This Service Information bulletin supersedes S.I. B72 03 02 **dated October 2002.**

Recall Campaign 02V-223: Recode Airbag Control Unit

E46 (3 Series) 323i and 328i

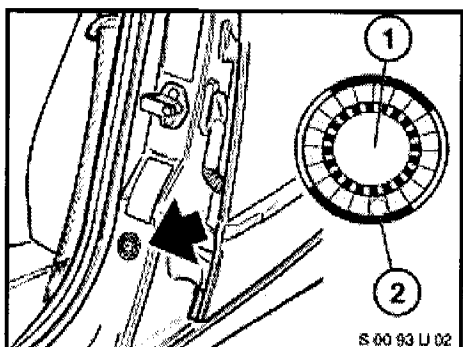
- a. emboss your BMW dealer warranty number in the middle of the label (1);
- b. punch out code number **342** printed on the label and,
- c. affix the label to the **B** pillar as shown.
